BRANCH SERVICE MEMO NO. 623CS

SUBJECT: Gaskets

DATE: 1/11/67

Units Affected: XL-700, 800 and 850

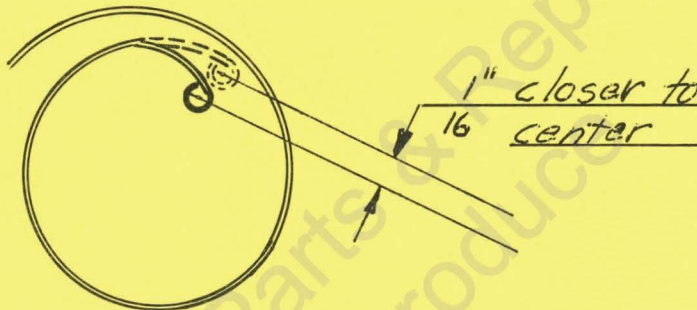
Here is a picture (slightly exaggerated to make it clearer) showing the last coil on an XL recoil spring.

By bending the innermost loop so that it approaches the center more steeply as shown, the spring stays engaged on the cam.

All units being produced now, and all recoil springs in Spare Parts, have been reworked. Please bend any springs in your stock as shown (it's easiest by using two pairs of pliers next to each other) before installing them.

SUBJECT: Fan Housing Screen Kit -  
Part No. A-64421

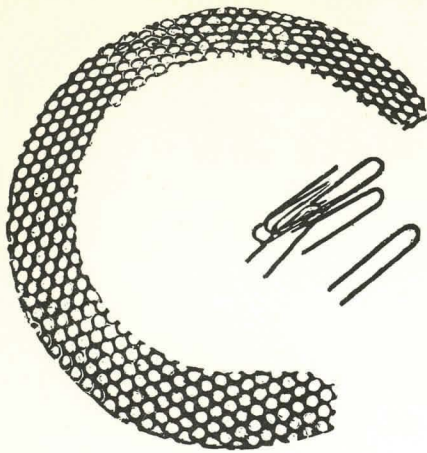
Take a look at the enclosed instruction sheet. It shows a picture of the new accessory screen which was designed for those XL-700, XL-800 and XL-850 chain saws which are used in the type of timber where chips get past the standard rotating screen on the inside and tend to clog the cylinder fins.

This accessory screen is held in place on the outside, by six easy-to-install clips, and may be substituted for the rotating screen when local conditions make it desirable to do so.

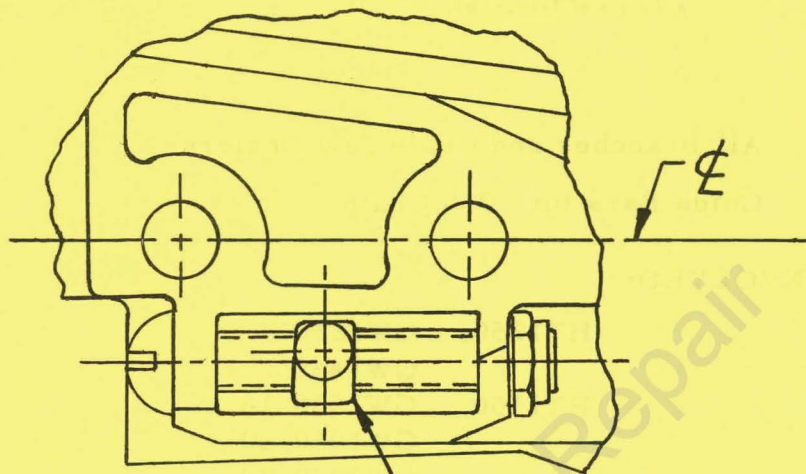
The mounting end of these guide bars has been redesigned to fit all Homelite direct drive chain saws (except the XL-101, 2, 3 and 4 series).

These bars have a 3/8" wide mounting slot to match 3/8" diameter bar studs. On XL Saws, an S-shaped spring, Part No. 64448, is used (and will be supplied from now on) to adapt the 3/8" slot to the 5/16" diameter studs on these units. If one of the bars is to be used on one of the XL's with planetary gears, two bushings, Part No. 64392 are required because the S-shaped spring won't clear the central dowel pin.

Here are two sketches showing the new set-up:

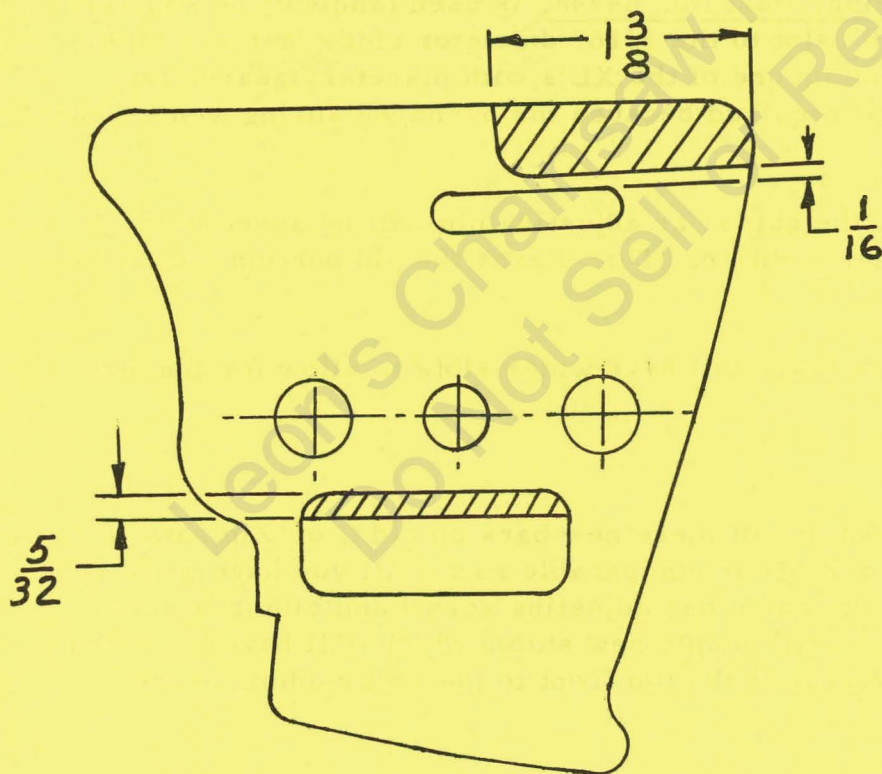
On all future C and Zip saws the guide bar adjusting pin will be assembled 180° reversed from its former position. This places the pin portion closer to the guide bar studs.

The guide bar shims for these units will have wider slots to allow for the new pin position.

It's also possible now to mount one of these new bars on old C or Zip saws -- or on any XP direct drive, or 775D or comparable saw. All you have to do is reverse the adjusting pin on the guide bar adjusting screw and either file out the slot in the shims or better still supply new shims which will have the wider slot and which will also be cut out at the top front to prevent rubbing of the side of the chain.

Assemble with offset towards center line of bar.

Shaded sections removed

FIG. #1

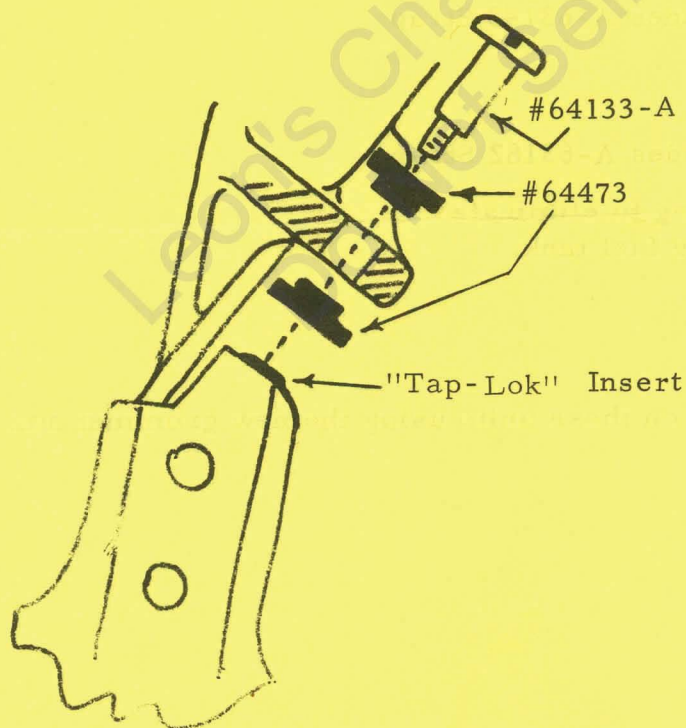
- I A new crankcase A-64902 supersedes A-63177-A. The upper mounting boss for the fuel tank has been shortened 1/16" and instead of a 1/4" stud a #10-32 tap-lok insert is used.
- II With this new crankcase we use a new fuel tank A-65324 which supersedes A-59999-1. The mounting hole has been opened up to 3/8" diameter. We will supply two (2) grommets #64473 with each spare parts tank.

These changes were made so that the two (2) grommets (#64473) and a shoulder screw (#64133-A) could be used to give the assemblies more flexibility. See Figure #1.

FIG. #2

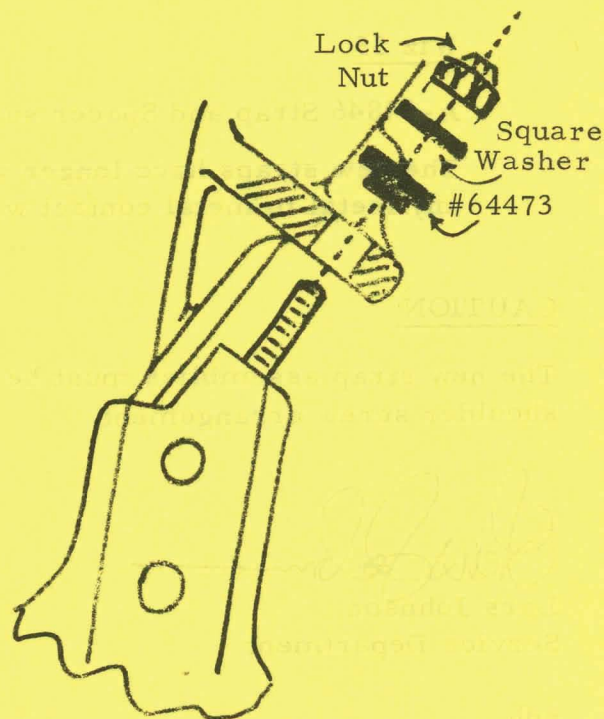
- A. If a new tank is ordered we will ship one with the 3/8" diameter crankcase mounting hole. If the crankcase is still the old "high" one with the 1/4" stud use only one grommet on top of the mounting tab and fasten with a square washer and nut (See Figure #2).
- B. If a new crankcase is ordered we will ship the new one with the #10-32 tap-lok insert. To use with an old tank, drill open the crankcase mounting hole in the tank; insert grommets on both sides and fasten with shoulder screw.
